Well Abandonment Completion Report

FILE NUMBER D(14-12) 26 BCA
WELL REGISTRATION NUMBER 55-580069

**Re: Variances for Five Monitor Wells
Registration Numbers 55-580068 through 55-580072**

FIGURE
13

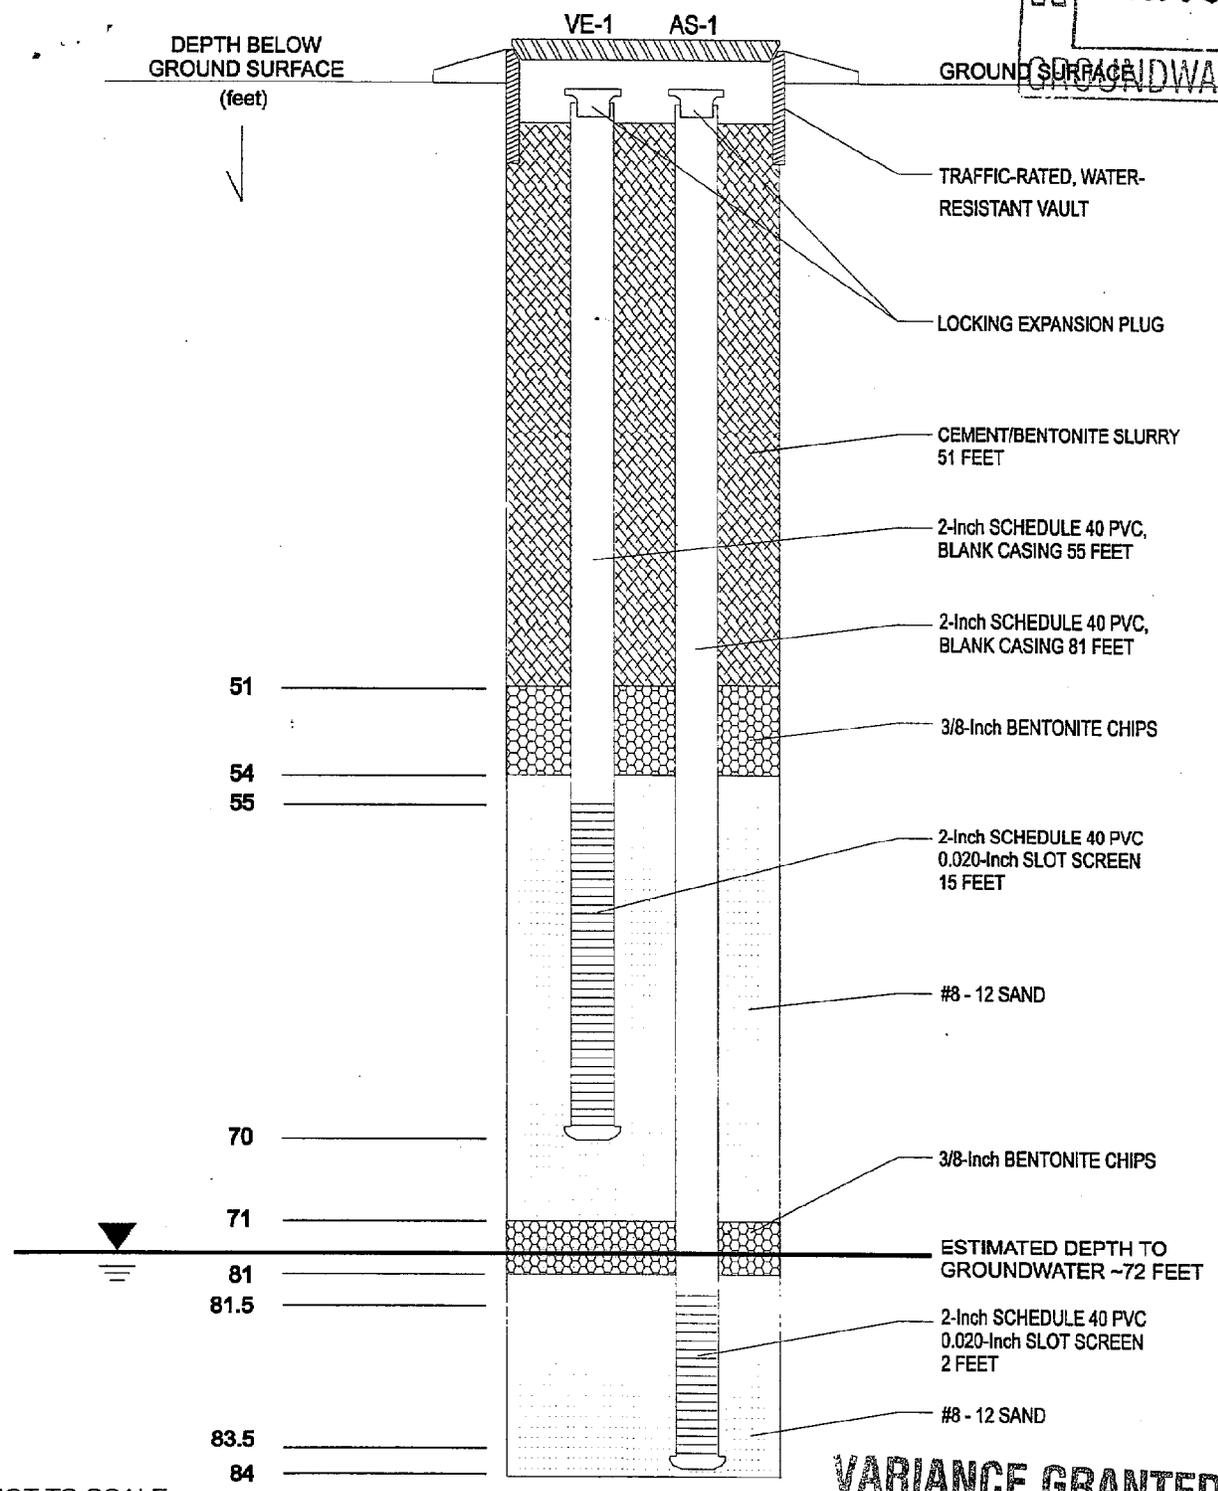
- * SCH 40 PVC casing will be used in lieu of the 20 foot steel surface casing.
- * The wells will be installed in sealed, flush grade, traffic-rated vaults because above-grade protective casing would interfere with traffic flow.
- * Due to the nested format, well screen will extend from 55' to 70' and from 81.5' to 83.5' BGS.

- Perforations may be installed between 55 and 83.5 feet below ground surface which is 17 feet above the record water level of 72 feet (R12-15-811.H.1.).
- Thermoplastic casing with a watertight cap may be used in lieu of steel (R12-15-811.B.1.).

- The PVC inner casings (risers) shall comply with ASTM Standard Guide D5092, Section 6.5.
- The wells shall be constructed per the "Variance Granted" Notice of Intention to Drill.
- The wells shall be abandoned (decommissioned) per A.A.C. R12-15-816.
